Work Order ID 96733

Item Name: Crosstube Fwd

DRAWING NO. D407-667-145	TITLE CROSSTUBE ASS'Y (407 HIGH FWD)	REV. C	DART AEROSPACE LTD ENGINEERING ORDER		D.E.O. NO. D407-667-145-C-1	SHEET NO. SHEET 1 OF 1	SCALE NTS
DRAWN qp	CHECKED ASS	MFG. APPR. IB	APPROVED WD		DE APPR. H		
DATE 11.07.15	DATE 11.07.22	DATE 11.07.22	DATE 11/07/22		DATE 11.07.21

DRAWING NO. D407-667-145		TITLE CROSSTUBE ASS'Y (407 HIGH FWD)		REV. C		DART AEROSPACE LTD ENGINEERING ORDER		D.E.O. NO. D407-667-145-C-2		SHEET NO. SHEET 1 OF 1		SCALE NTS	
DRAWN AJS		CHECKED A		MFG. APPR. E		APPROVED 140		DE APPR. 140					
DATE 12.08.02		DATE 12.08.02		DATE 12.08.02		DATE 12.08.02		DATE 12.08.02		DATE 12.08.02

DETAIL P
BONDING STRAP INSTALLATION 2 PL

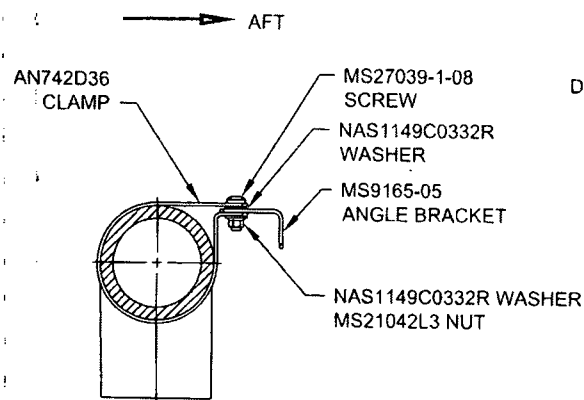
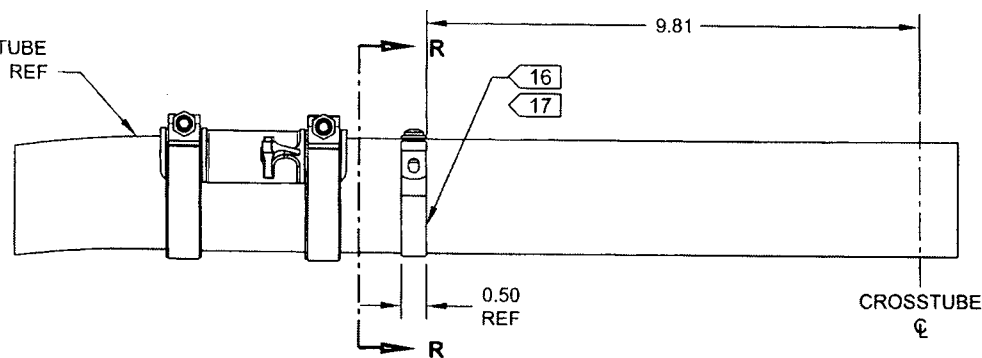
ADD ELECTRICAL GROUNDING STRAP

ADD

ADD
